SUBJECT: Information Report

Rezoning Application

To permit eight (8) detached dwellings on a CEC - private road

1629 Blanefield Road

TYPICAL EXTERNAL ELEVATION (LOT 5TO 7)

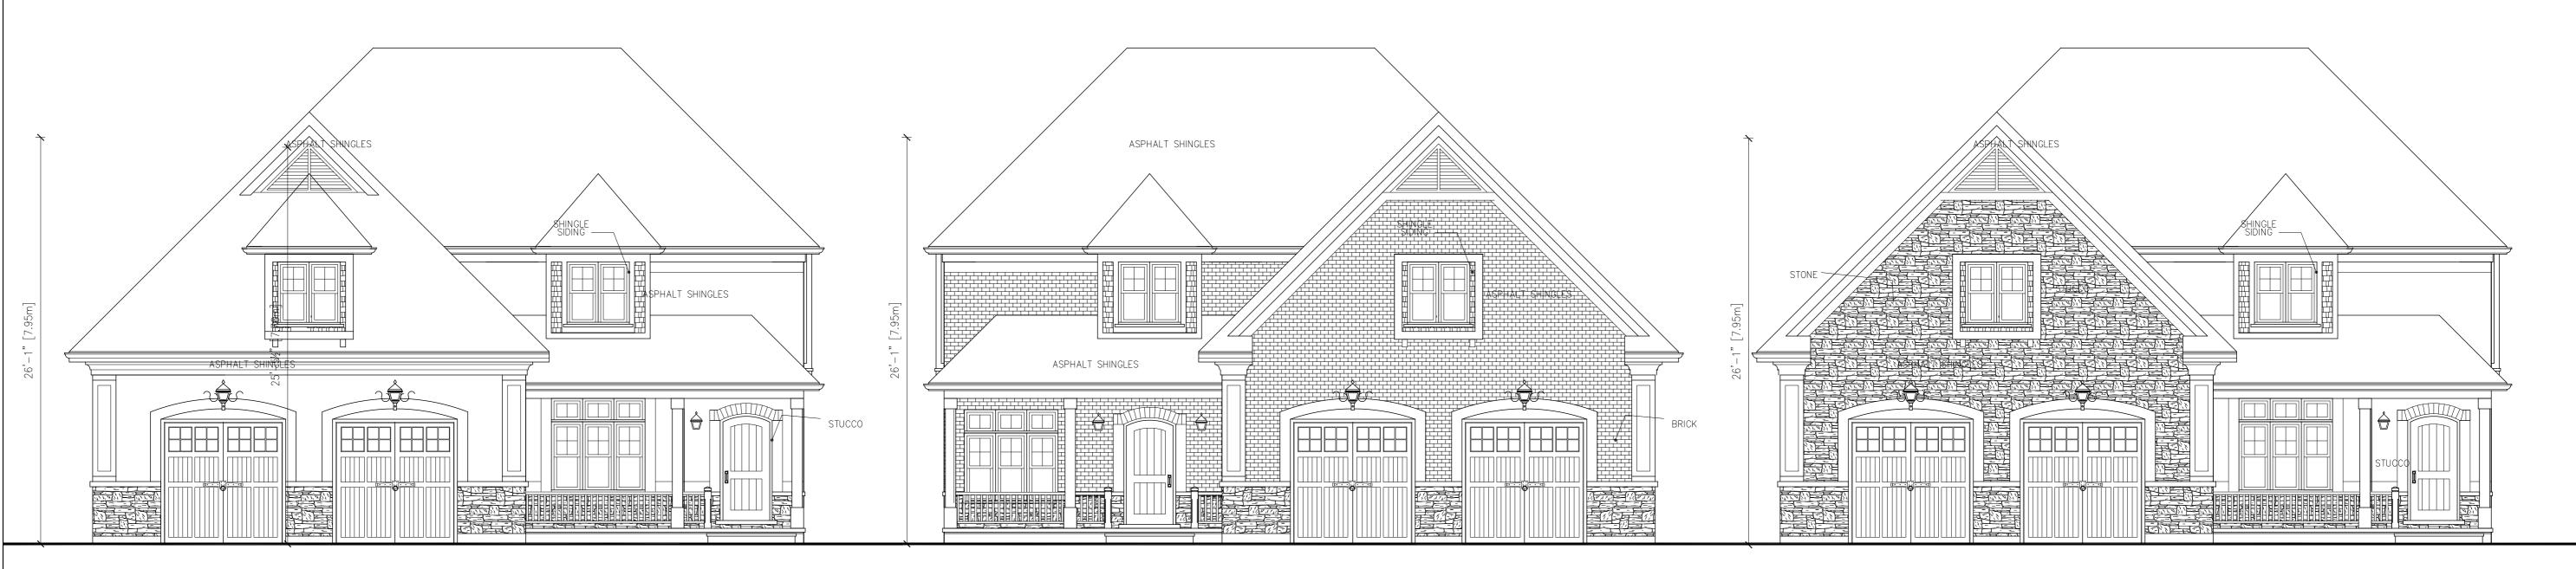
The applicant has provided conceptual elevations for each of the proposed units. Through the processing of the application, staff will require that the elevations meet the intent of the Infill Housing Policies (S. 4.24.3.1) of the Mineola District. The proposed elevations facing the public street for Lots 5-7 (see Appendix I-6, page 3) should be revised to de-emphasize the height of the buildings and be designed as a composition of smaller architectural elements.
